Addendum mumber 01	00 9113
Food & Nutrition Services		
Lost Mountain Middle School: Cooler and Freezer Replacement	t	202014
Hayes Elementary School: Cooler and Freezer Replacement		202015
Mount Bethel Elementary School: Freezer Replacement, HVAC		202016
System, Kitchen Hood and UDS		
	Delease Date	Cobruger 0 2021

Addondum Number 01

Projects: Lost Mountain Middle School 700 Old Mountain Road Kennesaw, Georgia 30152 CCSD # S5S005LMTM

- Owner: Cobb County School District 514 Glover Street Marietta, Georgia 30060
- Architect: MWL Architecture, LLC 17 Summerfield Crossing Acworth, Georgia 30101

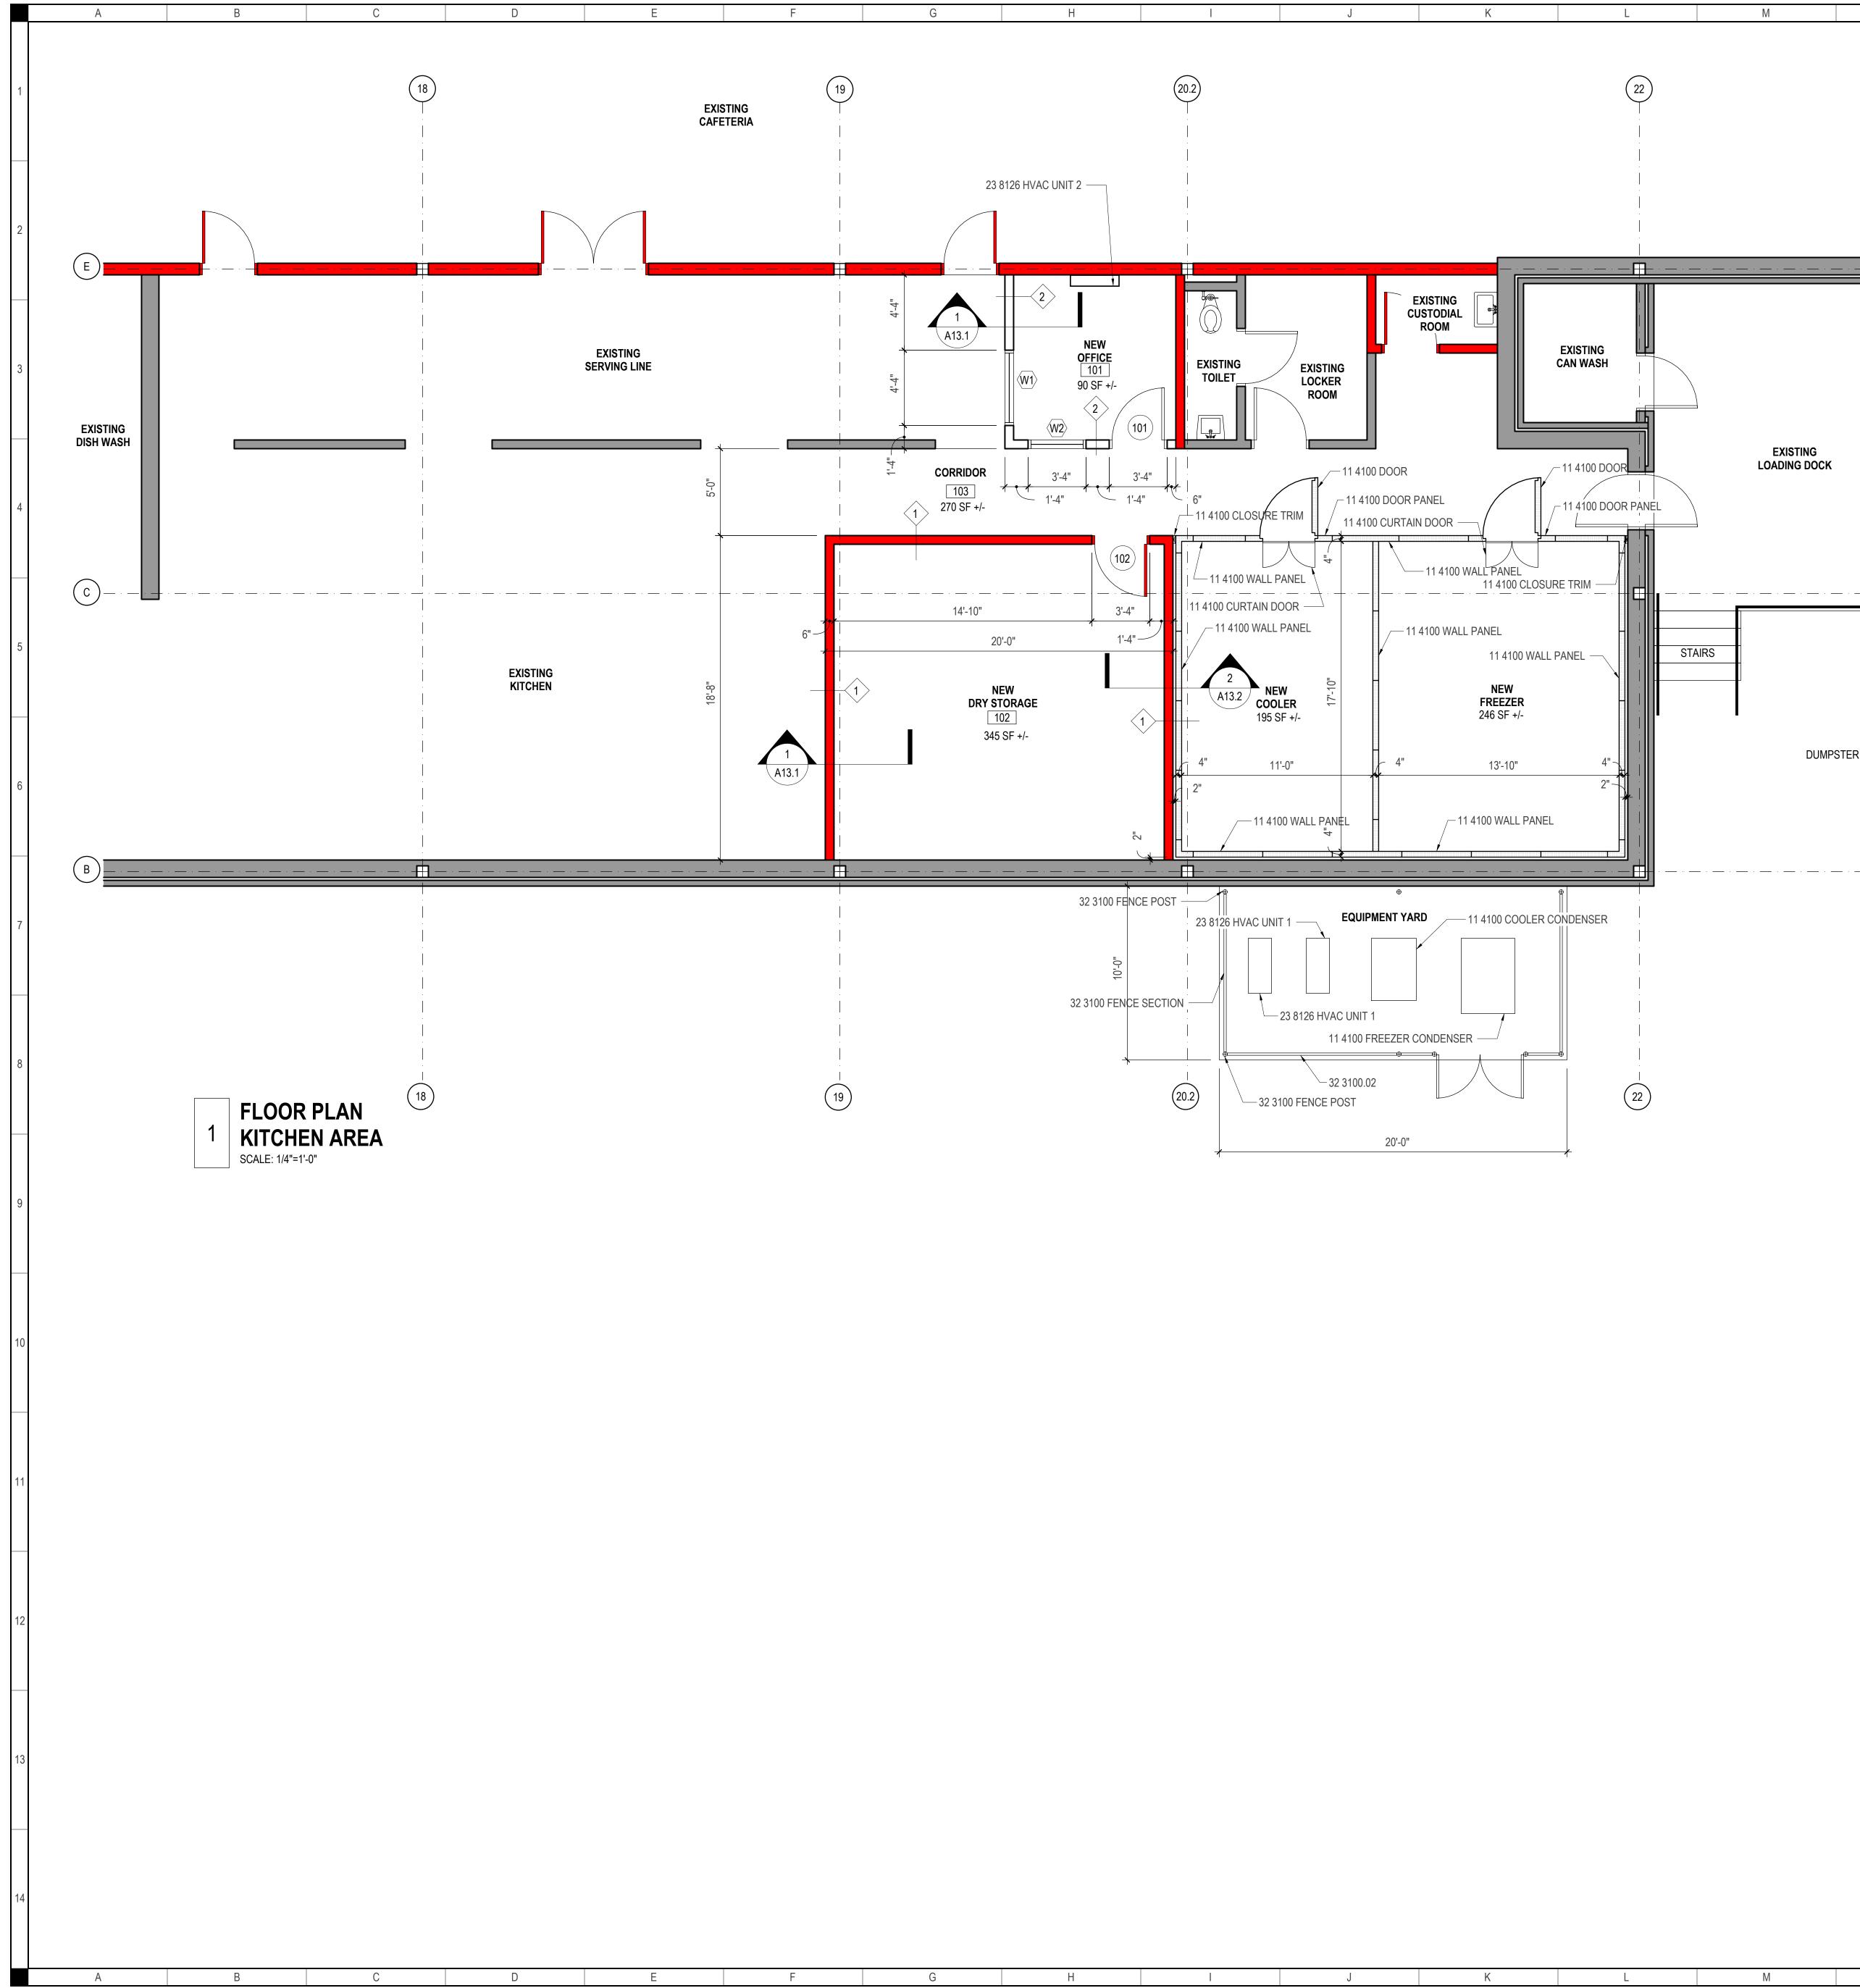
ADDENDUM-1 REVISE FINISH SCHEDULE FOR THE DRY STORAGE ROOM 101, OFFICE 102, & CORRIDOR 103. FLOOR & BASE FINISH SHALL BE QUARRY TILE.

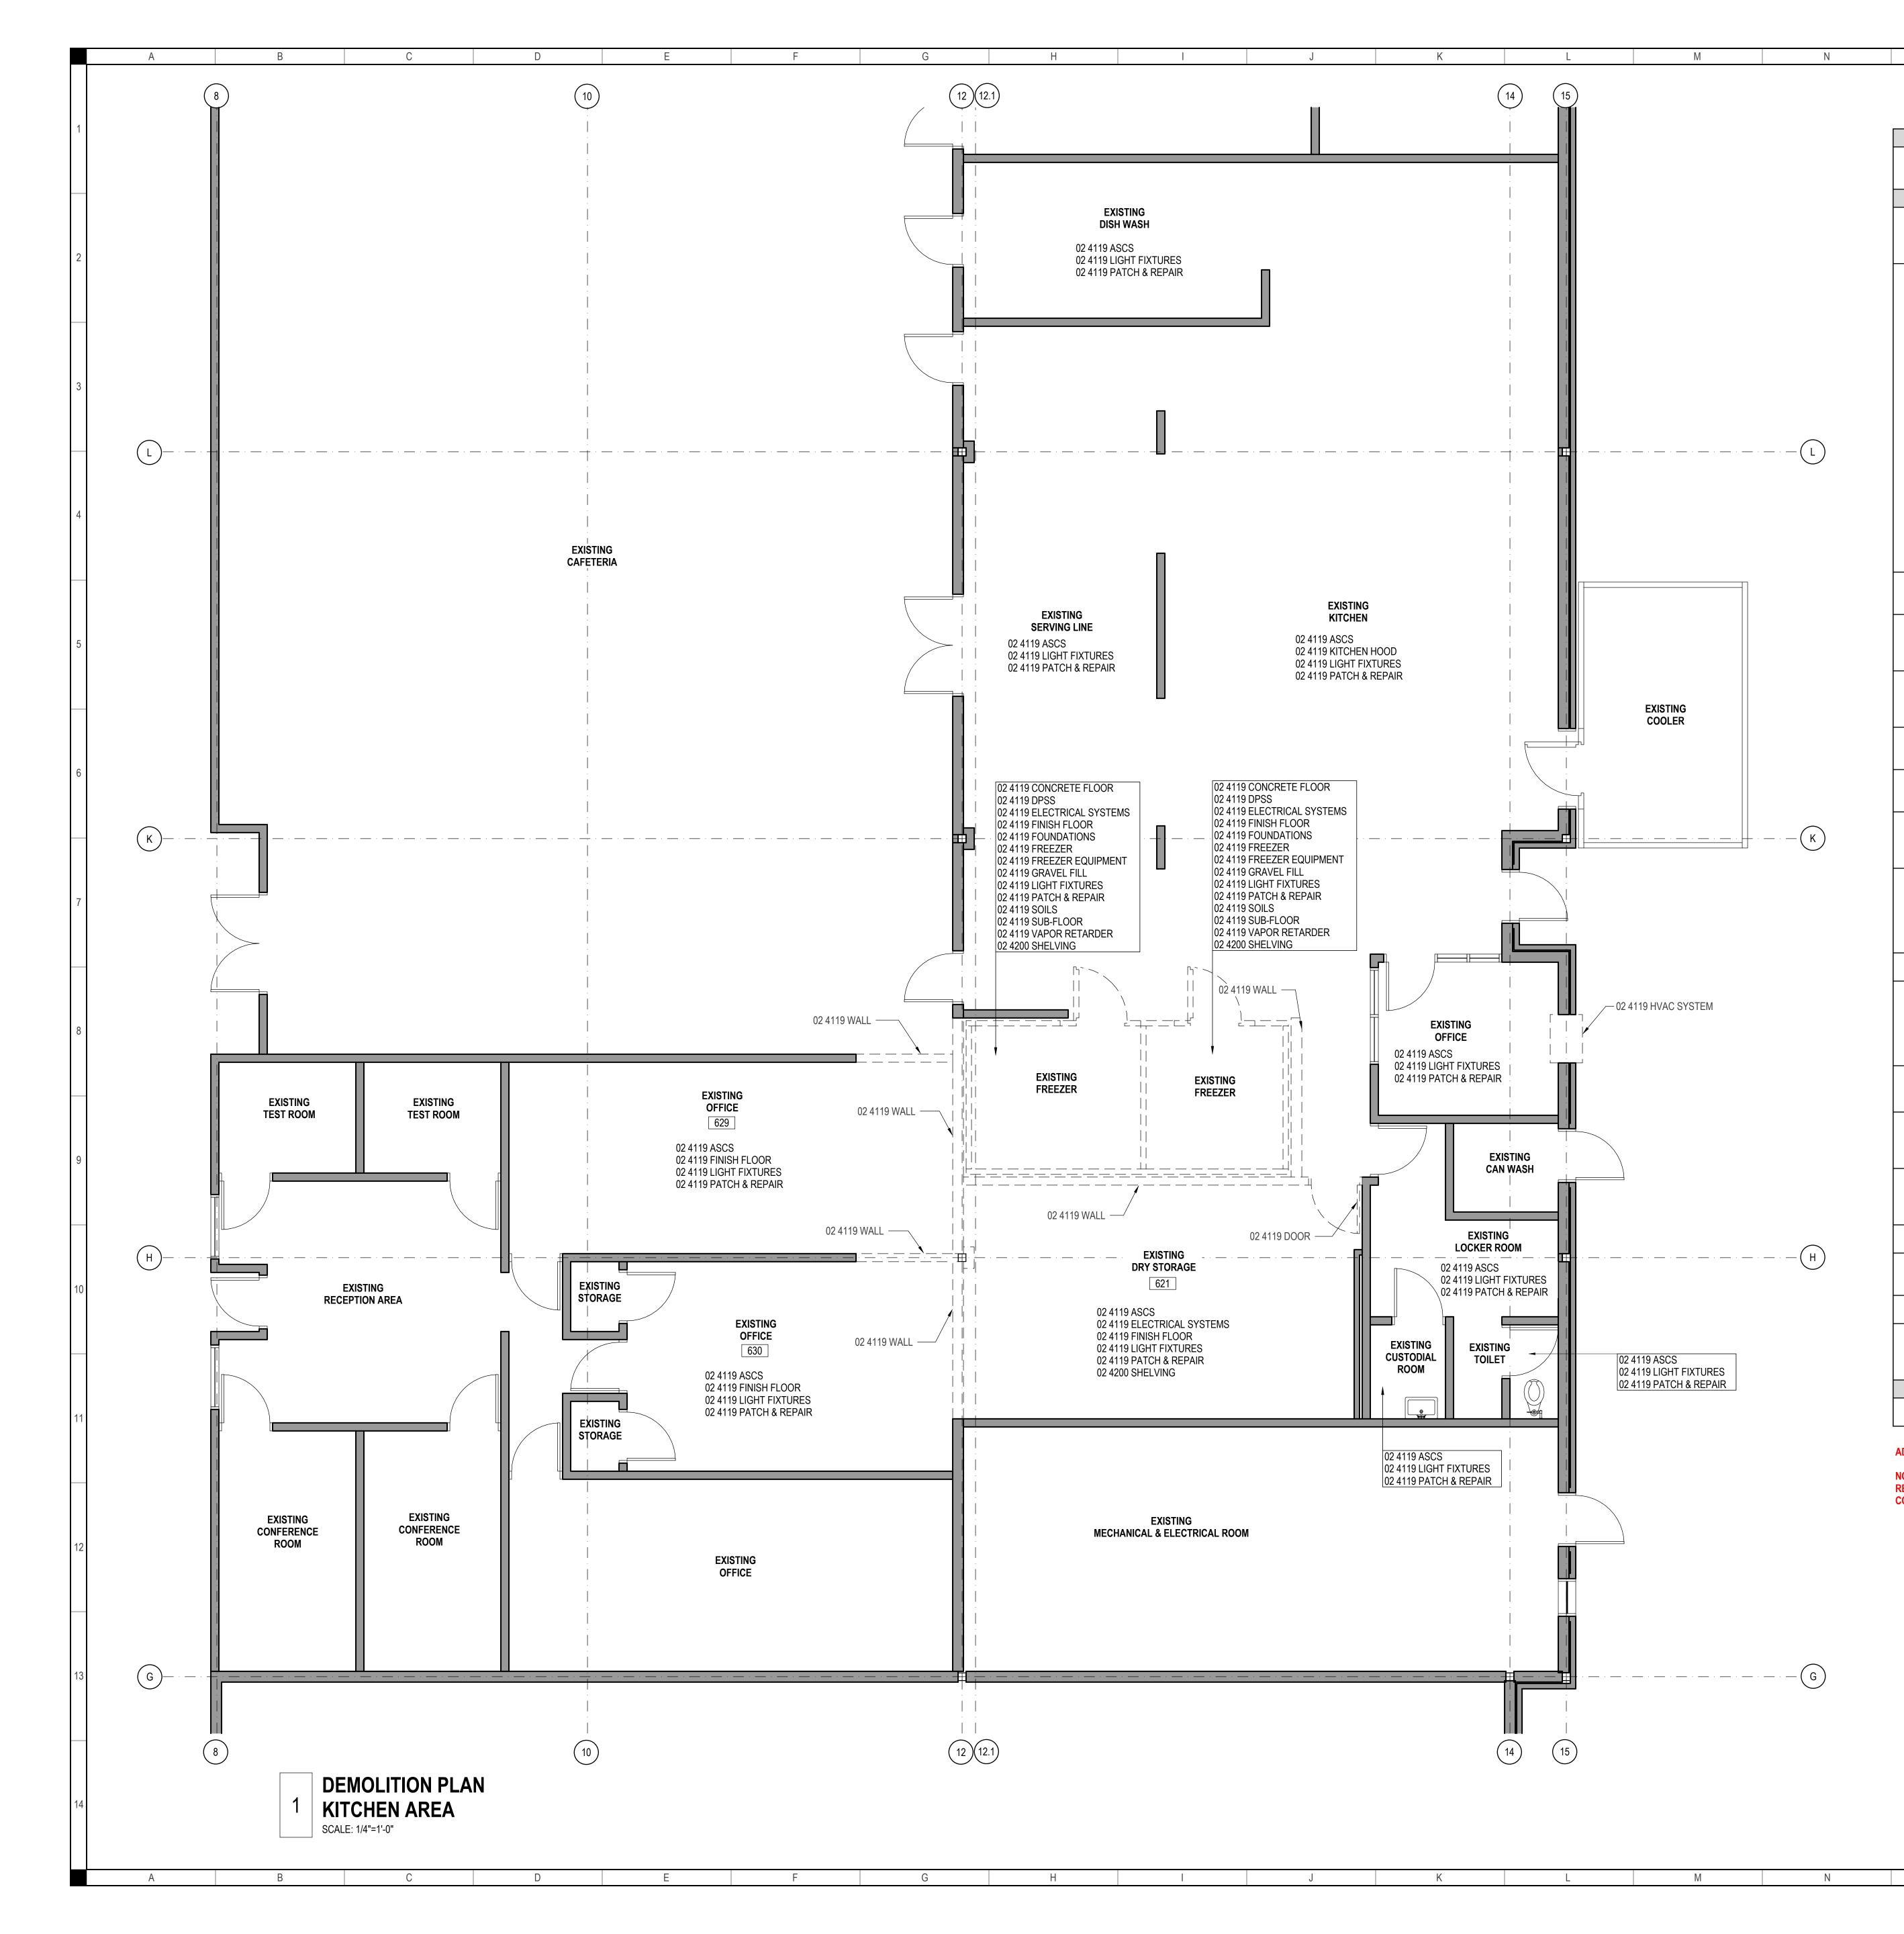
NOTE-1 SHEET A3.1 DEMOLITION PLAN RELOCATE EXISTING BIKE RACK, COORDINATE NEW LOCATION WITH OWNER. DEMO EXISTING BOLLARD IN CONFLICT WITH LOCATION FOR OUTDOOR MINI SPLIT EQUIPMENT & FENCING, CUT & PATCH CONCRETE.

A6.1

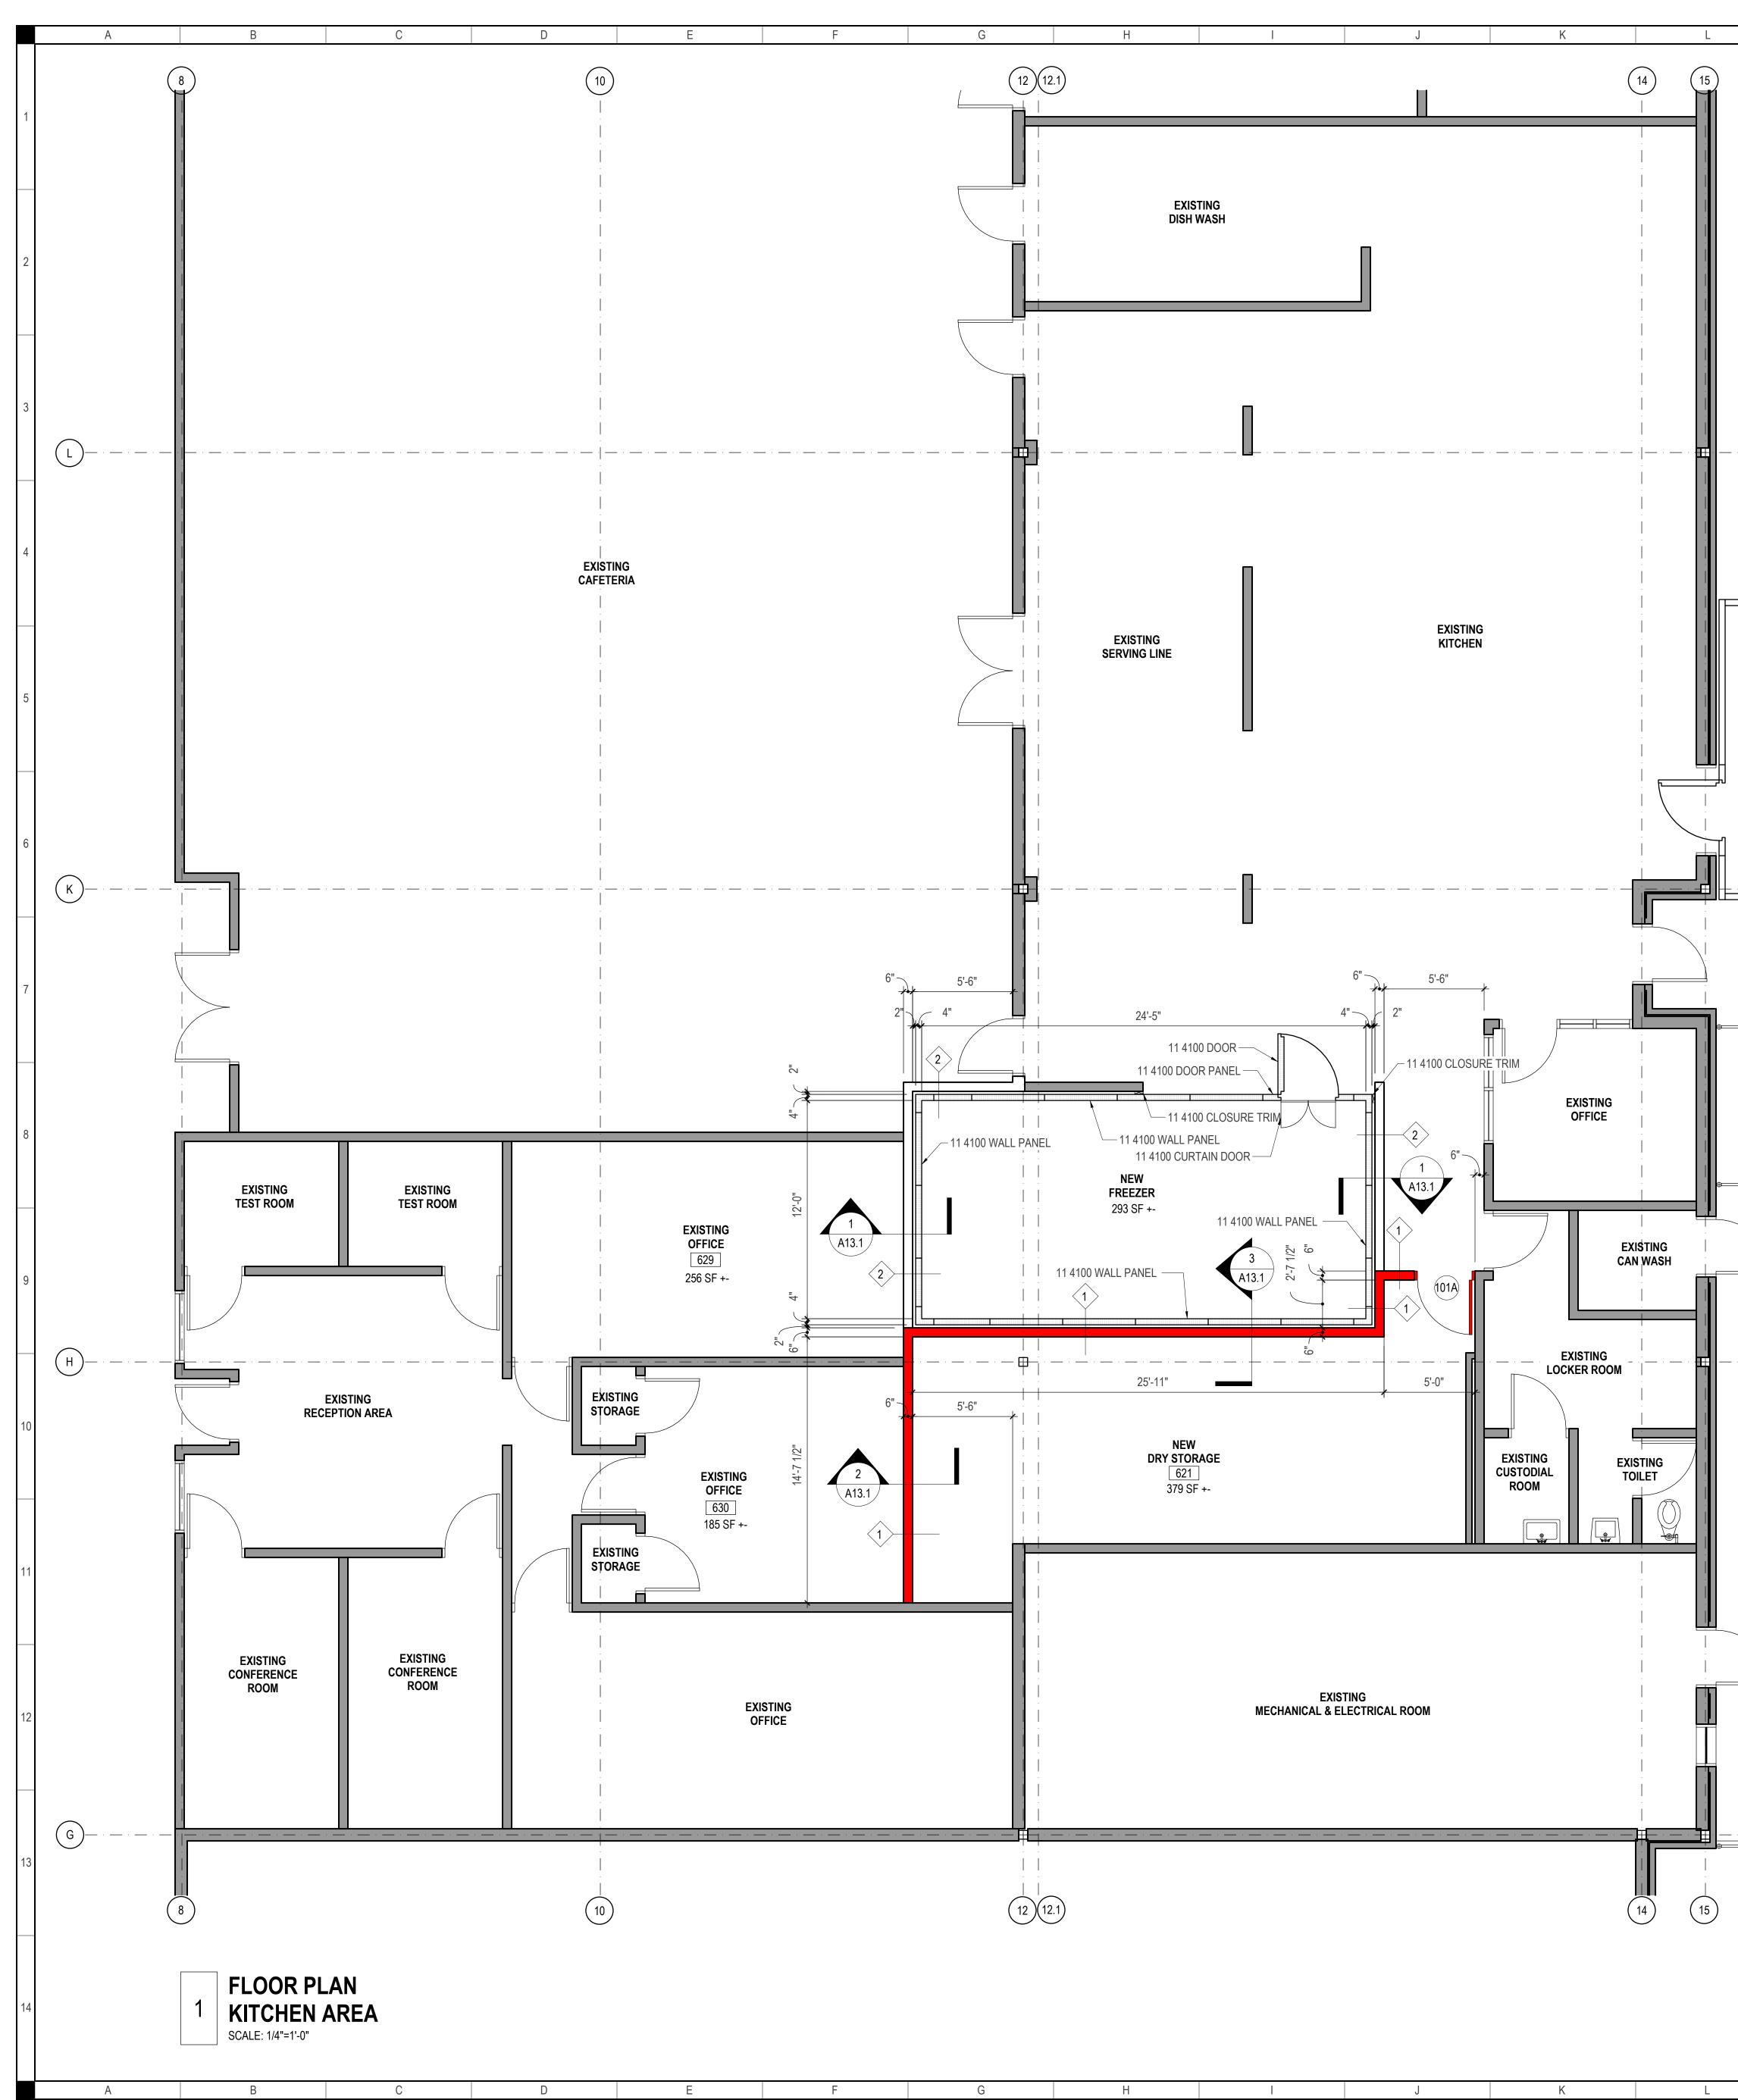
ADDENDUM-1 RELOCATED FREEZER & COOLER CONDENSER EQUIPMENT, INCLUDING FENCING & GATE. SEE SHEET A6.2
